2-NSW-188 (Sheet 1 of 2)
Instrument Room Ventilation
Unit 3 Return Line

LIVSEY & COMPANY, INC.
INDIANA & MICHIGAN ELECTRIC CO.
DONALD C. COOK NUCLEAR PLANT

DWN. **MA** DATE **3/12** CONTAINMENT # **2**
 CKD. **MA** DATE **3/12** DWG. NO. _____
 ISSUED **2-NSW-188** 1
 REF. DWG. **2-5102** SHT. 1 OF 2

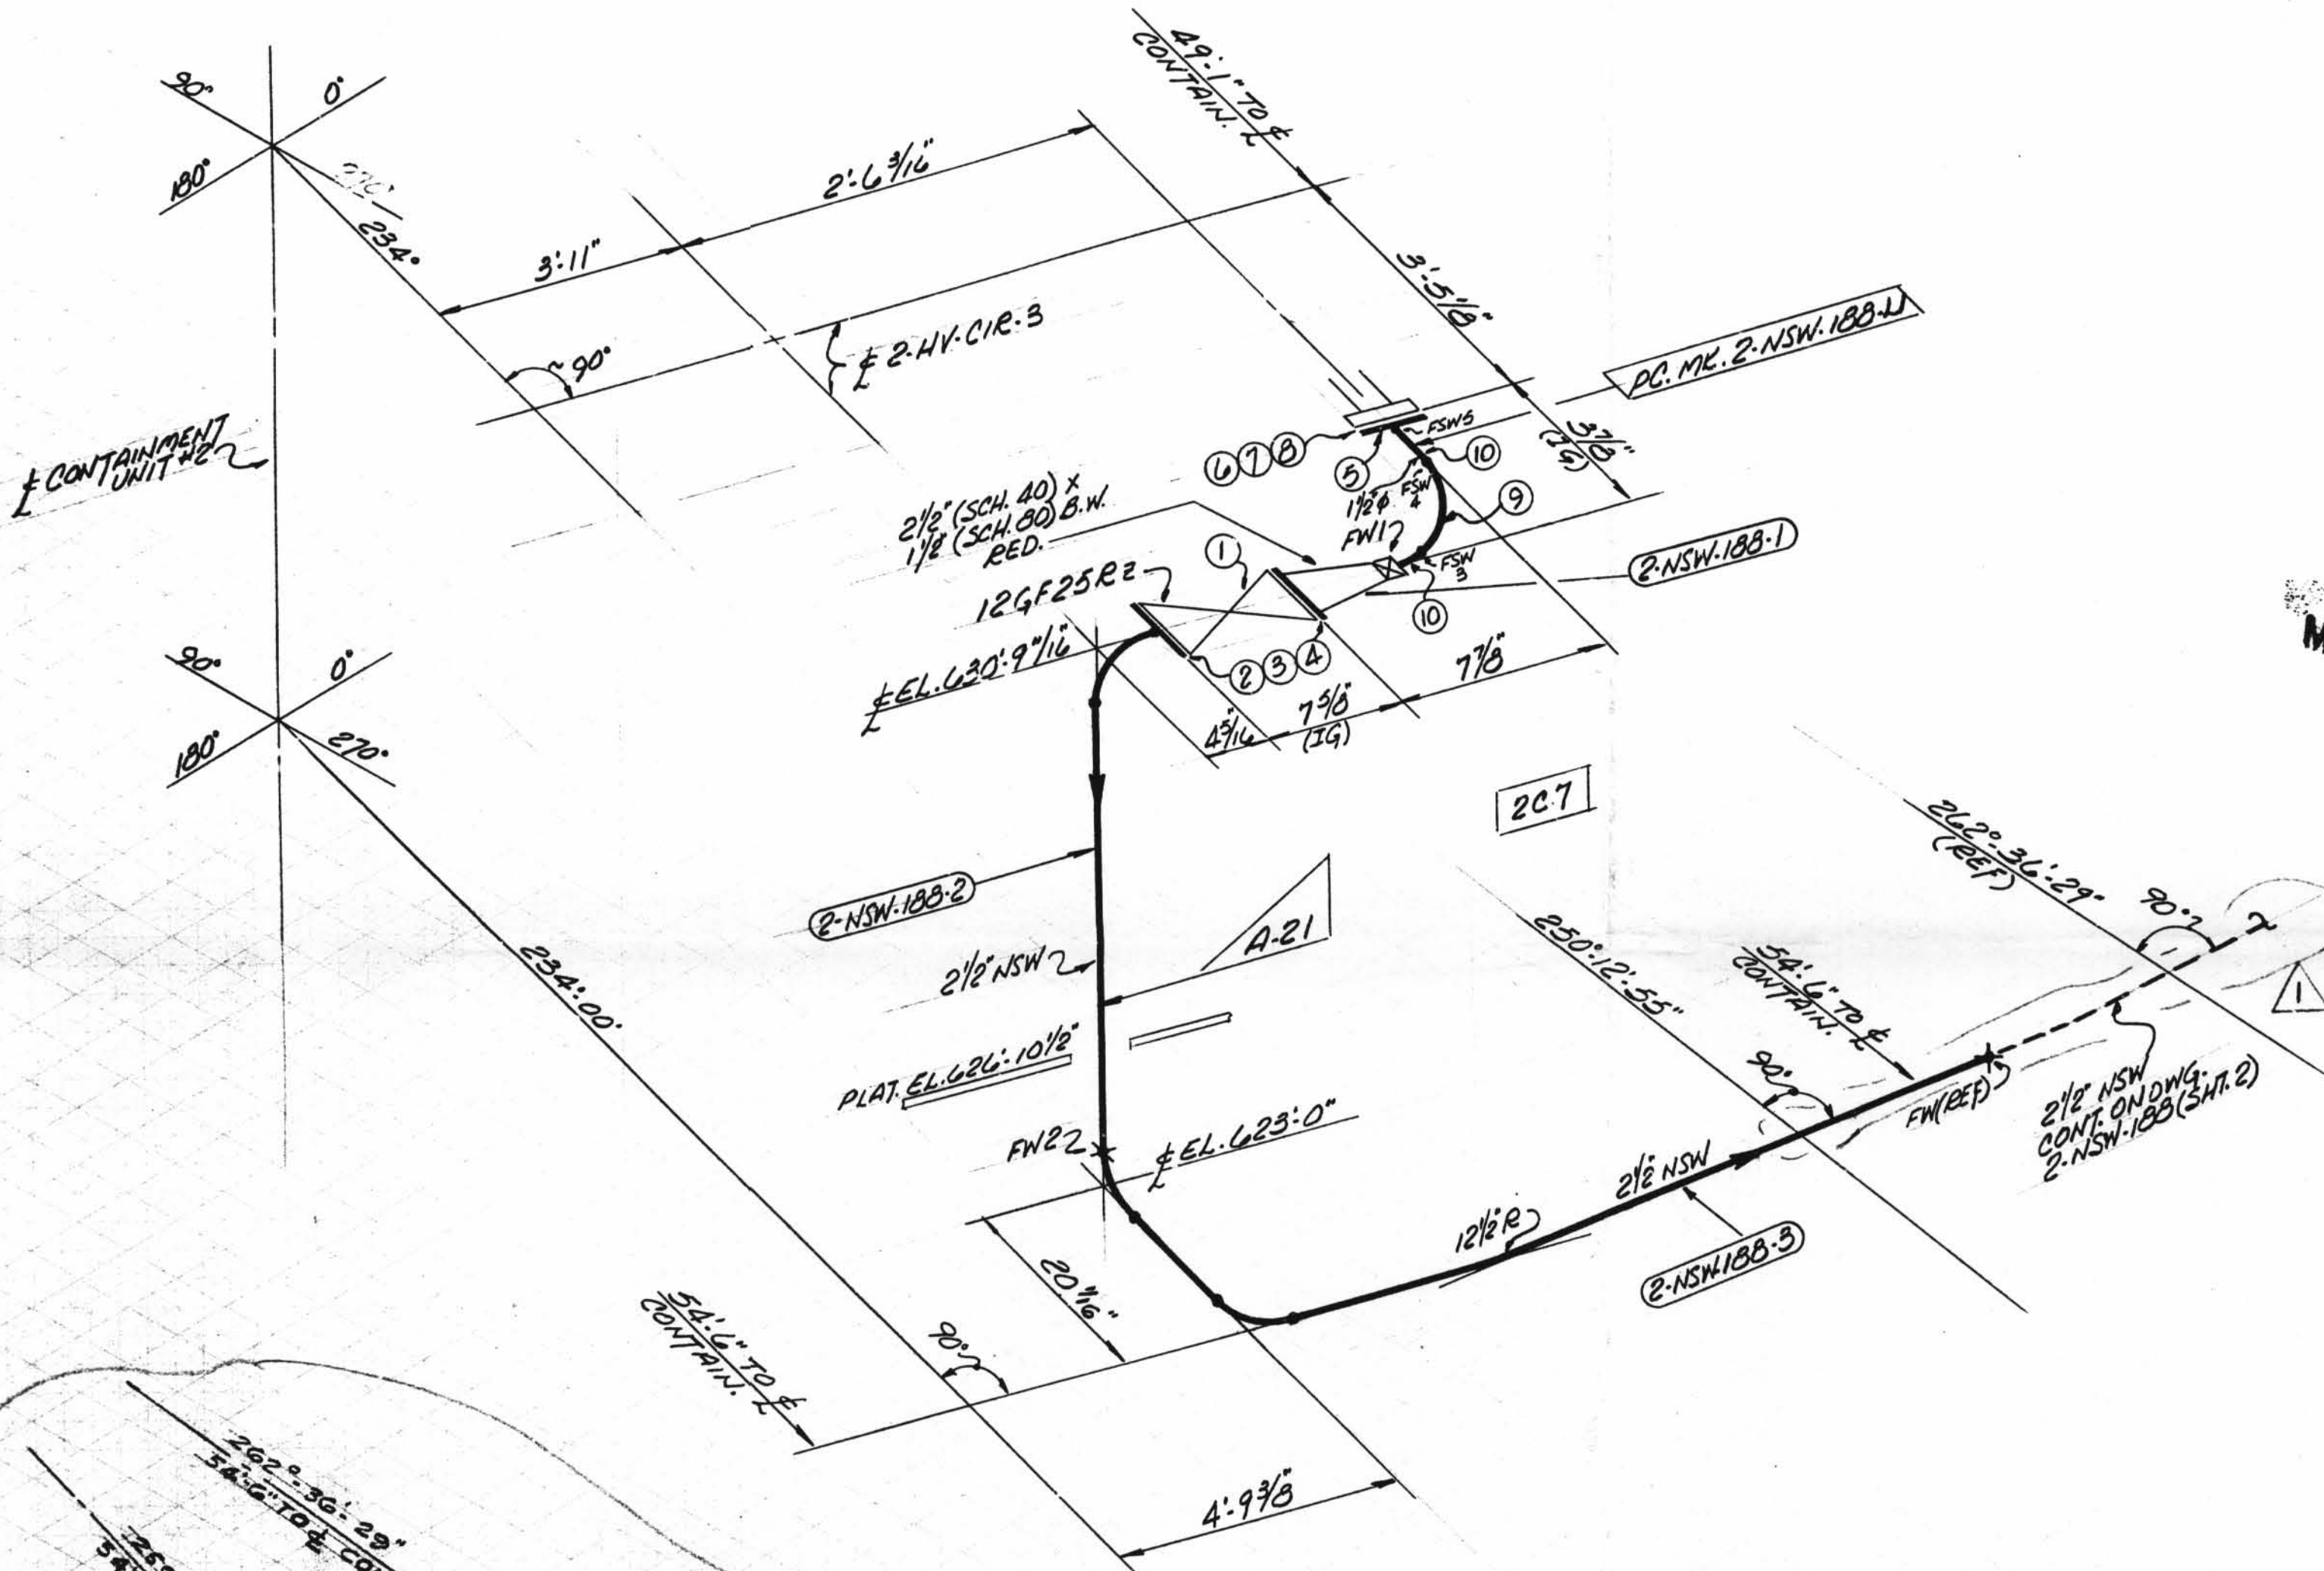
REVISION RECORD		
NO.	DATE	DESCRIPTION
1	11/30/78	PER RDM MC-0582 ADDED AS BUILT DIMS. AND REVISED PIPING DOTTED LINE INDICATES AS BUILT.
